**Feedback on Council's 9-Year Plan  
In respect of South Dunedin's Inadequate  
Storm-water Infrastructure**

## **A CONSULTATION PROCESS SUBMISSION WITH REGARD TO DCC'S NINE YEAR PLAN**

**The following consists of some comment on a report that 3 Waters staff have presented to Council as Item 14 South Dunedin Flood Alleviation – Short Term Options to Inform Meeting 28 January 2025.**

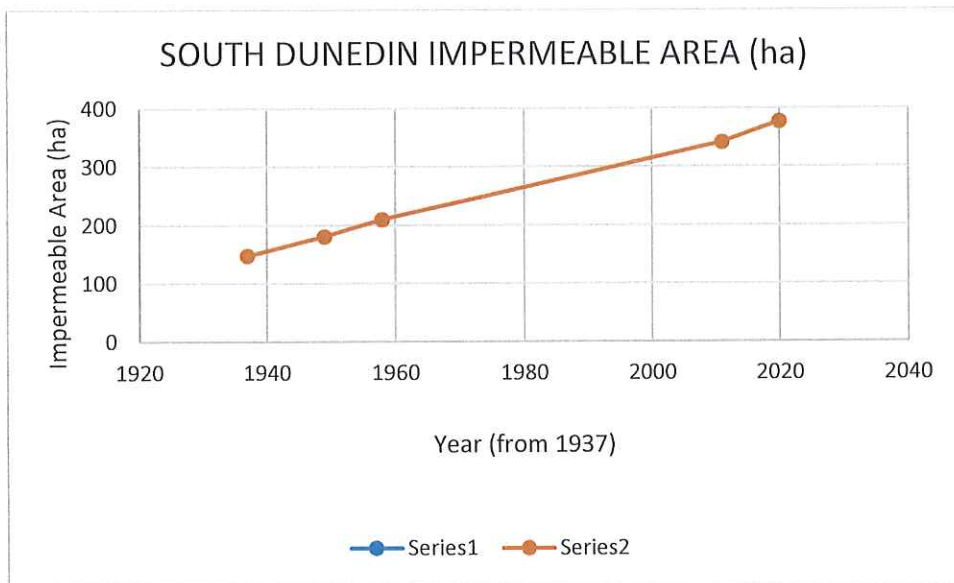
My findings are outlined in the attached summary and graph. In brief, the amount of impermeable land required to be serviced by the storm-water drainage system has more or less doubled since the 1940s or thereabouts. As a result, the envisaged ability to handle rainfall intensities of some 14 mm/hour has reduced by half to about 7 mm/hour or less, as was evident in the relatively minor rainfall event of February 2020.

In my professional opinion, the historic and ongoing increase in impermeable land across the South Dunedin catchment is the most significant and urgent flood issue facing the community. It has arisen entirely independent of any threatened climate change considerations, and might have been addressed in a timely manner had the Council received more accurate and detailed engineering analyses after the flood events of 1968 and 2015. It is an issue that, also in my opinion, needs to be addressed as a compelling priority.

**Rainfall Chart - Flood 2015 - 3-4 June (Rainfall mm/hr over 36 hours)**

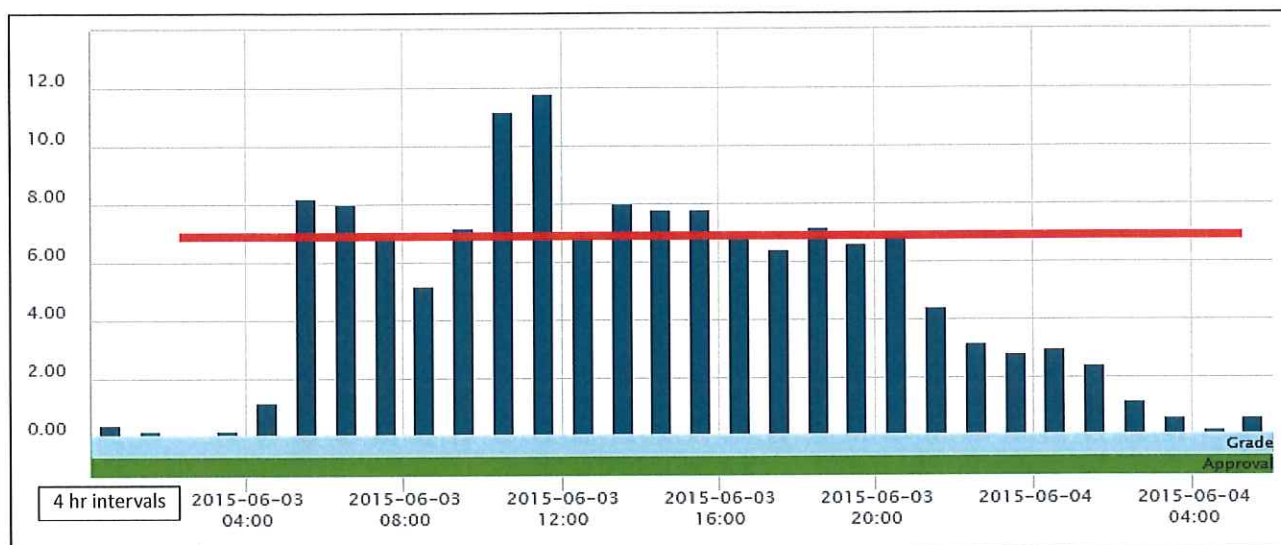
6. The lesser flooding experienced in October 2024 compared with June 2015 was simply a consequence of a considerably less demanding rainfall intensity distribution in the latter rainfall event when several periods of lighter rainfall intensity allowed the pipe and pumped system to "catch up" with demand. (Refer graphs attached). The benefit of work carried out by DCC at the pump station's screen is minimal, and arguably zero.

3. DCC has maintained that flooding across South Dunedin was less extensive in 2024 than in 2015 because of "improvements" that have been made. This is an extension of the myth. The reason that 2024 was a smaller flood event than 2015 can be found in comparison of the rainfall distributions across the two events. Refer the hourly charts of rainfall intensity, for which the key work was undertaken by experienced engineer, Julian Doorey. I have superimposed a 7mm/hour threshold line to identify the periods when rainfall intensities were arguably (by me) sufficient to cause flooding. There were 14 such hourly periods in 2015, and just nine in 2024. But more significantly, there were 6 hourly periods during the 2024 flooding event timeframe when rainfall intensities dropped substantially below the threshold, but none in 2015. The effect of the periods of reduced intensities was to allow the pipe and pump system to partially empty and "catch up" so that the risk of prolonged flooding did not materialise. That had everything to do with good luck, and nothing to do with good management.
